SURREY COUNTY COUNCIL

SUBJECT: LONDON ROAD GUILDFORD ACTIVE TRAVEL SCHEME – INDEPENDENT TECHNICAL ASSESSMENT OF SECTION 1 FOR CONSIDERATION TO PROCEED.

Project title A3100 Burpham to Boxgrove Roundabout Technical Review
Job number 293908-12
File reference 04-08
cc
Prepared by [REDACTED]
Date 7 June 2024
Subject Technical Review

Figure 4 Road users and widths

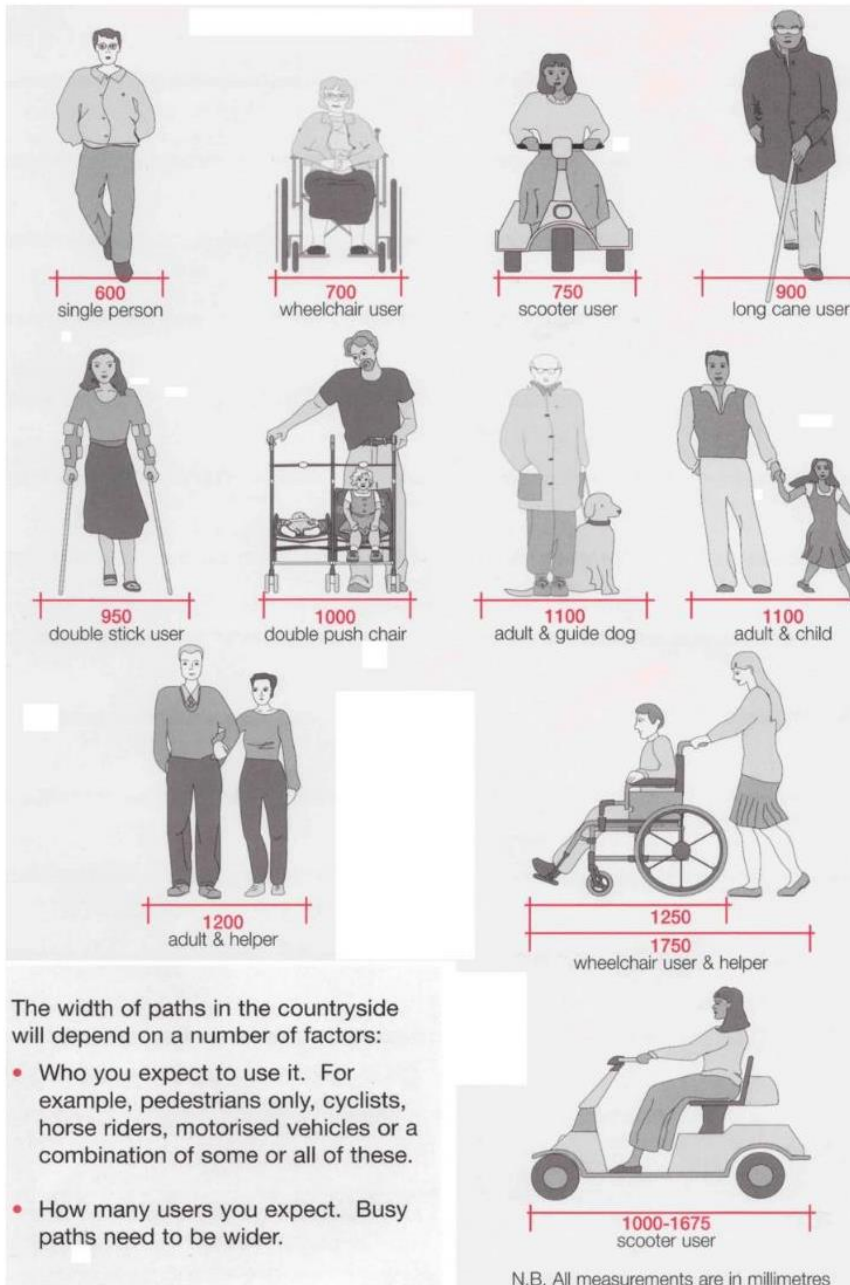
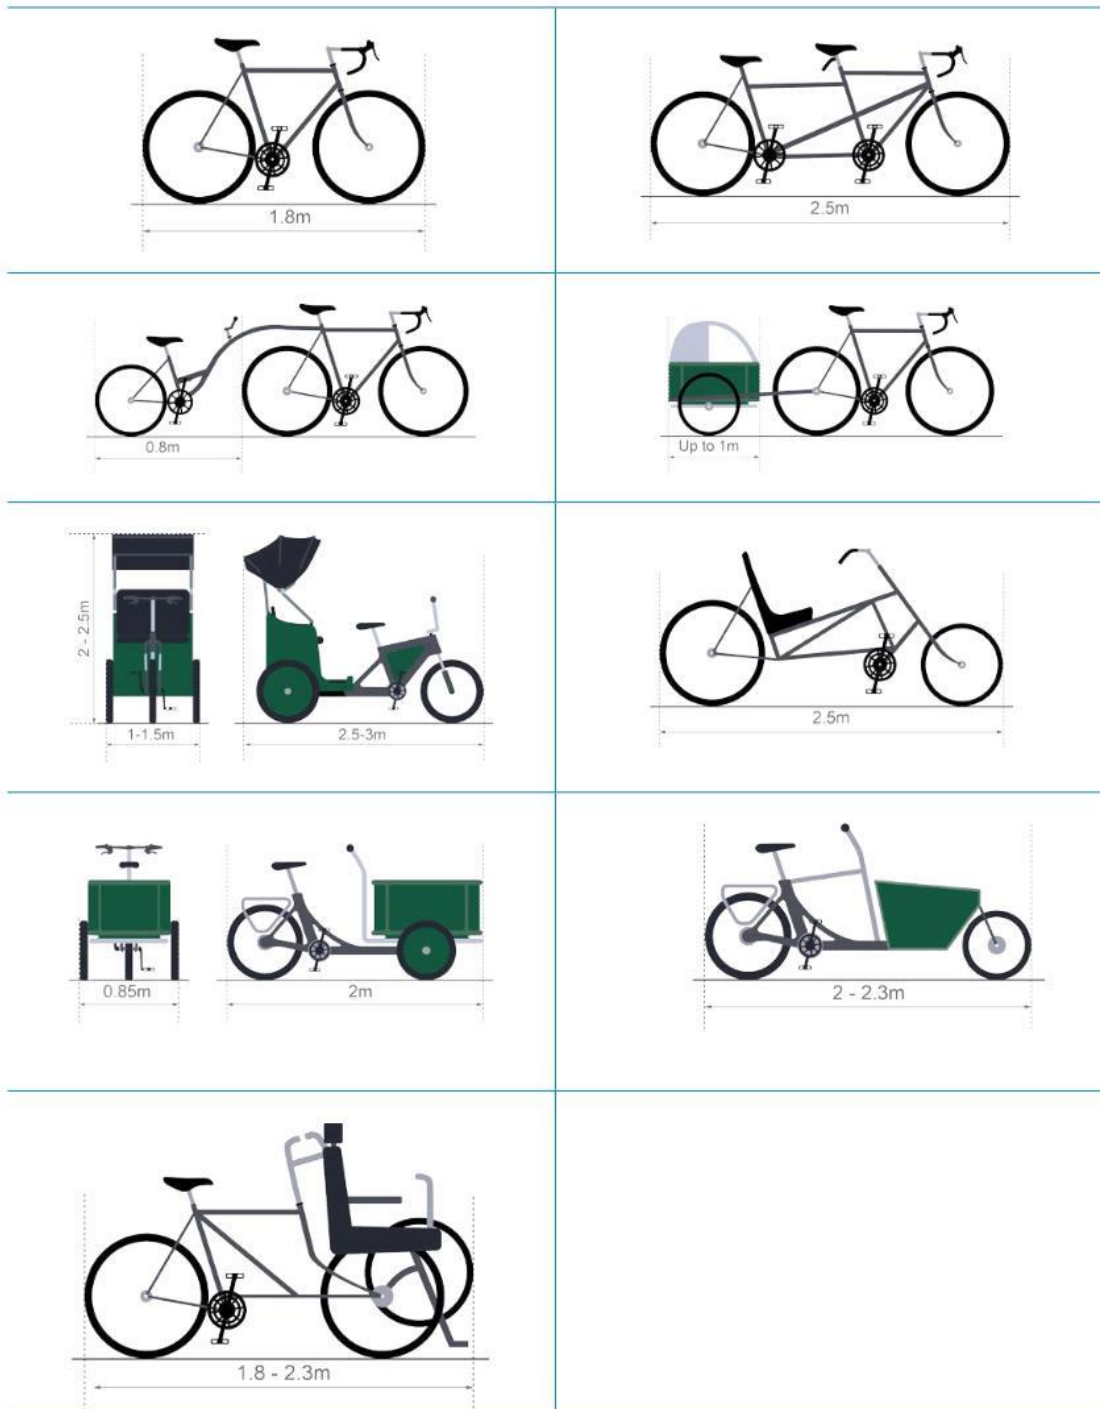
Figure 4 shows typical vehicle dimensions. The maximum width of a vehicle in the UK is 2.55m, although there are exceptions such as refrigerated lorries. Cars are typically 1.8m width but new cars such as sports utility vehicles (SUVs) can be wider.

In the UK, design vehicles include cars, refuse vehicles, buses and articulated lorries. HGVs and buses are the widest with an assumed 2.55m width although this does not account for elements such as wing mirrors that extend out from the vehicle body (figure 4 refers). Including wing mirrors indicates an overall vehicle width of approximately 3.0m.

Example 2

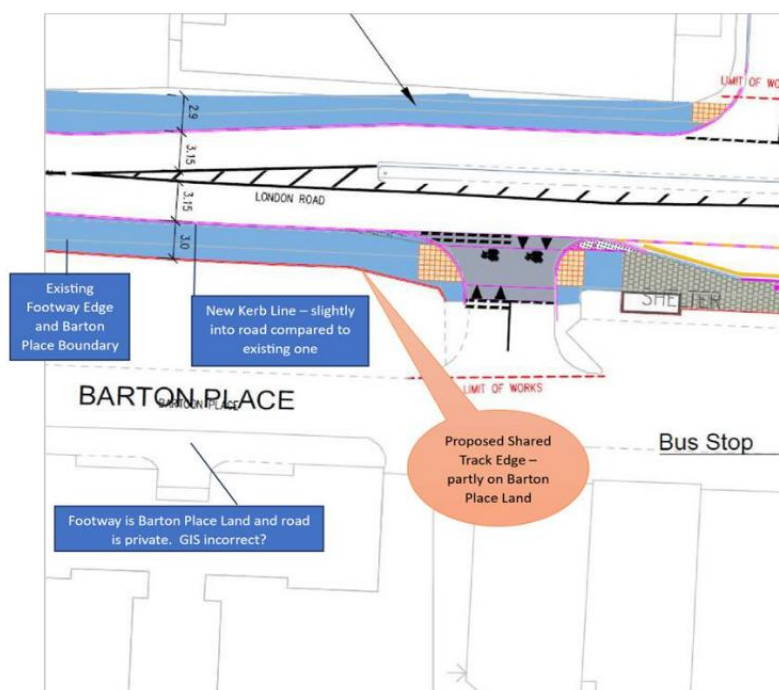
Watching bus and lorry traffic it is clear that with the current road width, particularly southbound, maintaining a course such that the wing mirrors between the cycle lane and the 'centre' line leaves minimal clearance on the straight parts of the road and is physically impossible on bends. Most vehicles cross both lines when negotiating the bend approaching the first Abbotswood junction. Even northbound there is very little clearance.

Barton Place (part of Land Registry title SY 173174) appears already to have been subsumed to create a shared path, though latest check of Land Registry shows no transfer of title, or part thereof.
